Addendum No. 1

Sylvan Union School District

STOCKARD COFFEE ROOF PROJECT, BID NO: 2018-19 #4

MODEL - RHG

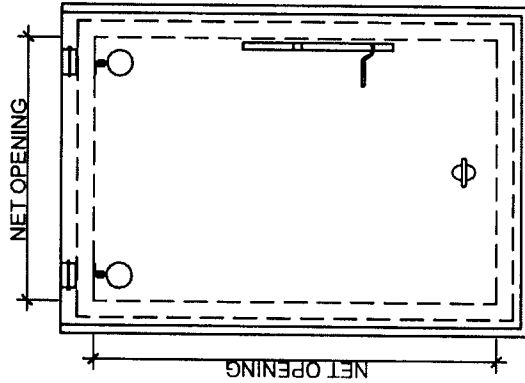
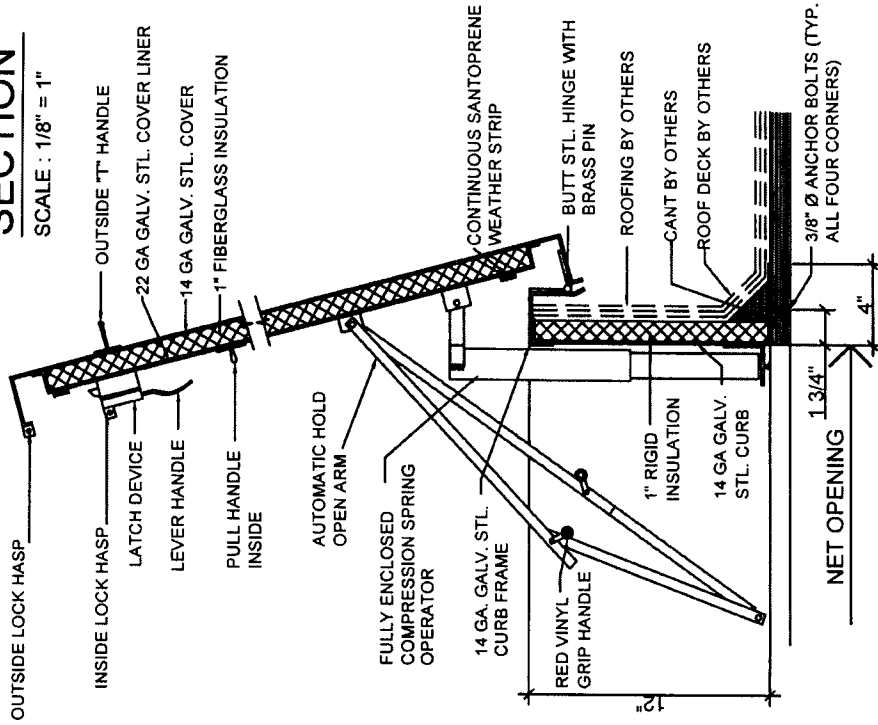
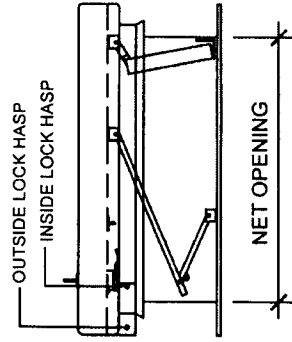
- Install new Roof Hatch and Guard Rail Product as specified (see attached). Contractor is responsible for specifying required model or equal product from the following choices:

- Lane-Aire Model RHG 3844 (30" x 36" ID)
 - Lane-Aire Model RHG 4444 (36" x 36" ID)
 - Lane-Aire Model RHG 4456 (36" x 48" ID)
3. See amended Bid Form: All Bidders shall include Unit Cost Allowance for:
